CULVER AIRCRAFT CORPORATION
WICHITA, KANSAS

SERVICE MEMORANDUM

NO. 12

SUBJECT: Alteration of Front Stabilizer Attachment to Fuselage.

FIG. 1

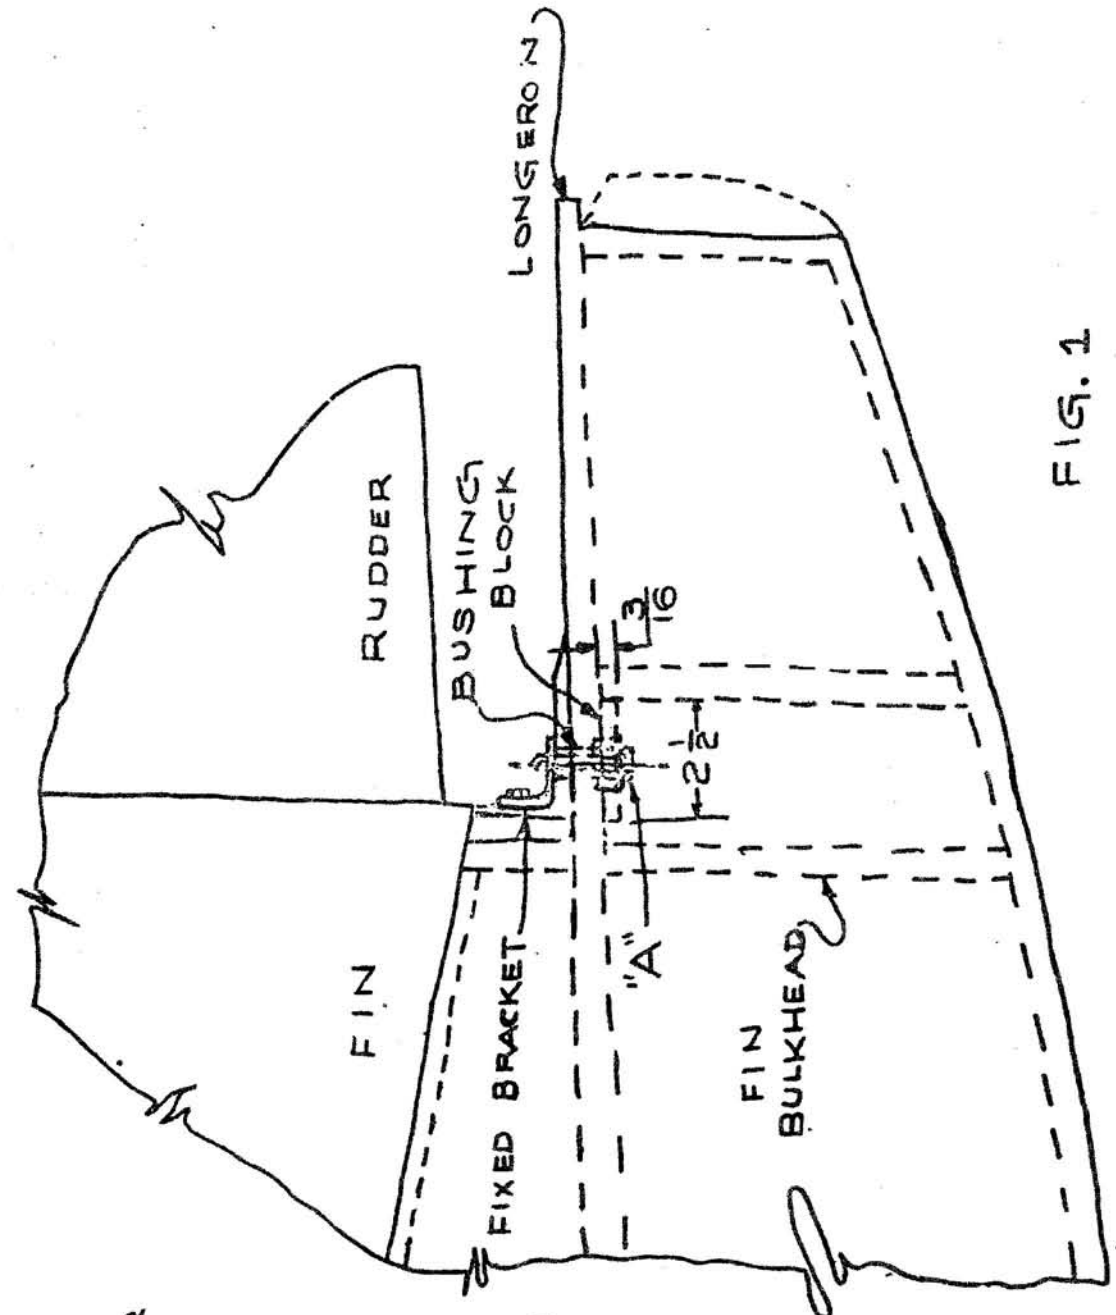
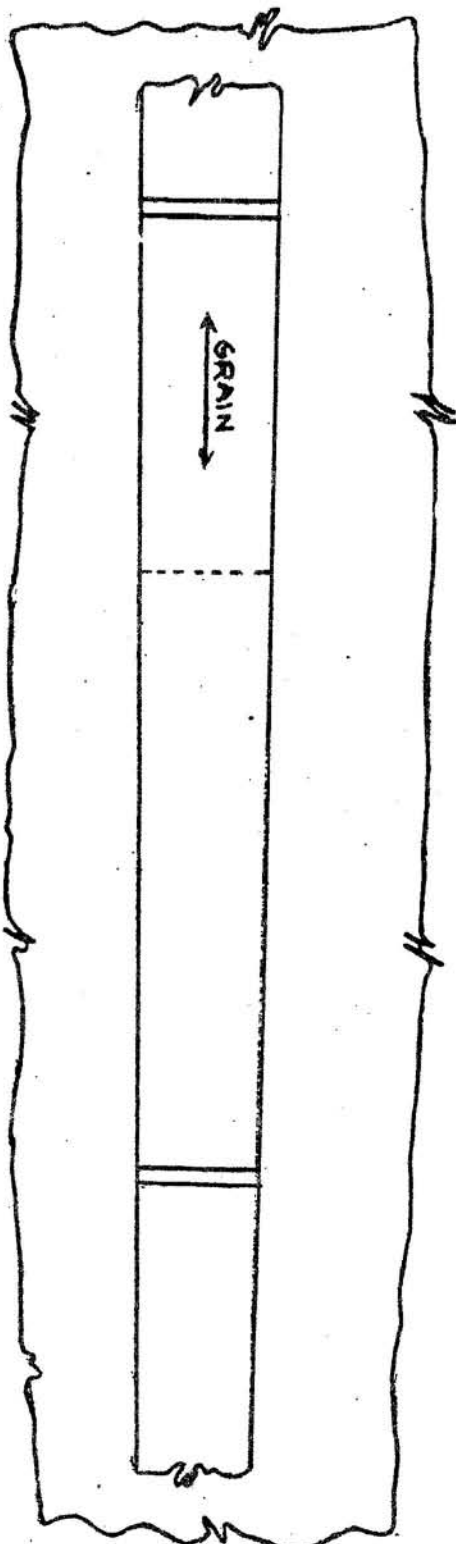
Glue a piece of aircraft quality birch, maple, or black walnut plywood 3/16" thick 1-1/8" wide and 2-1/2" long to the underside of the longeron as shown in Fig. 1. Use aircraft quality casein glue mixed according to directions.

Reinstall horizontal tail, replacing the front mounting bolts with AN4-16A bolts fixed from rotating as shown on Fig. 1.

The bolt hole will have to be drilled thru the plywood block on the bottom, using a 5/16 drill. If your airplane did not have a bushing, the hole will have to be drilled out to 5/16 as well as drilling the block.

A bushing, 1-3/16" long of 5/16 OD x .028 wall steel tubing is to be inserted in the hole.

DRN	CHK	APP	TOLERANCE	SCALE: 0"=1'0"	FUSELAGE STRUCTURE	MODEL - 1
					TYPICAL	
					LONGERON SPLICE	
					CULVER	
					AIRCRAFT CORP	
					WICHITA KANS.	
					798

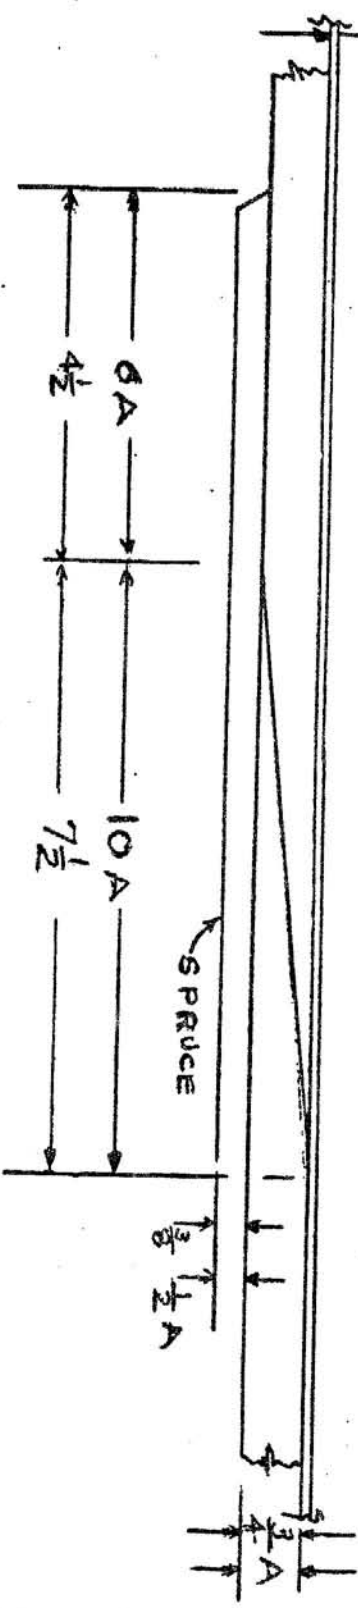
If one or both longerons are crushed, they will have to be spliced in accordance with Culver Drawing No. 798, a copy of which is attached. This drawing shows a typical longeron splice. If the skin is split or cracked a panel, from longeron to longeron and from bulkhead or vertical to vertical, must be replaced using 10 to 1 scarf joints. If longeron does not have to be repaired, remove steel bushing if one is installed, scrape off lionoil from under side of the longeron and the skin for 3/8 in. below the longeron between the rear side of the fin bulkhead and the vertical member aft of the front attachment fitting.
